Annexure 10

Wind Advisor Assessment

From: Michael Donn <michael.donn@gmail.com>
Sent: Wednesday, 29 June 2022 2:30 pm
To: Matthew Brajkovich
Subject: Re: Resource consent application - 1 Molesworth Street - SR 514663

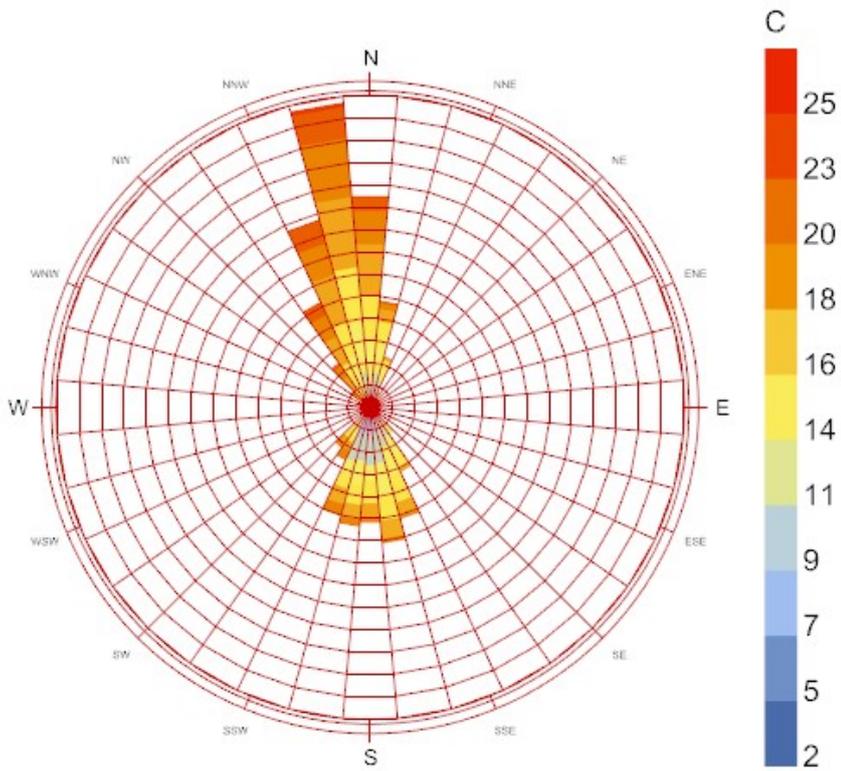
This overall assessment comes together in the AEE document: *"Wind speeds in localised areas can be reduced when screens for example are orientated at right angles across the ground level wind flows. However, for other reasons (i.e. CPTED, maintaining pedestrian access, adverse visual effects etc) they may not be practical. The report finds that "taken overall, wind conditions are improved with the proposed development" (p23).*

"For the proposed pedestrian areas, at the detail design stage it is proposed that wind mitigation along with other design factors (such as visual effects, CPTED, security considerations etc) will be further considered and assessed with the objective of making the proposed pedestrian areas as safe and attractive as practicable."

Dry Bulb Temperature (C)
 city: Wellington
 country: New Zealand
 time-zone: 12.0
 source: TMY2 NIWA 18234 D14482
 period: 1/1 to 12/31 between 7 and 18 @1
 Each closed polyline shows frequency of 1.1% = 50 hours.

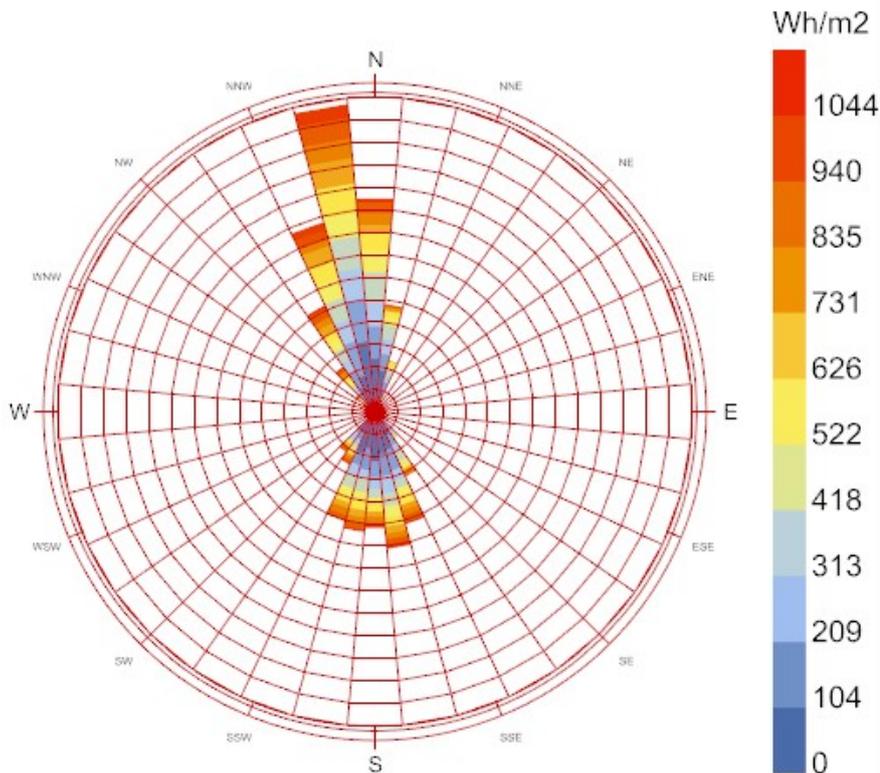
1) I can find no discussion of the performance of the adjacent park area in regards to the City's performance requirements for parks. Is this OK?

Such a discussion might / should address the following data:

If I look at wind in Wellington in relation to when it is warm, the strong Northerly winds are closely associated with the most warm temperatures (during the day from 7am to 6pm):
